Product Change Notification (PCN)

| PCN Number | 508159 | Date Issued | January 17, 2020 |

Impacted Products Pictures

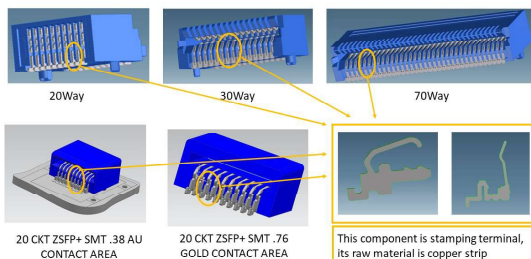
| Change Type Description | This letter is to inform you that production of the part(s) identified in this notice is being moved to a different production location. No changes will be made to the product as a result of this move. | | |

- In order to avoid the potential supply chain risk:
 - Molex Chengdu will qualify the second source of copper strip .
 - Molex Chengdu will add local qualified vender as stamping source, then able to run terminal production in both locations Molex Chengdu & local qualified stamping vender.
- Product Impact: No impact to fit, form or function
- Part Number Impact: see attached impacted parts list
- Qualification reports and samples available upon request
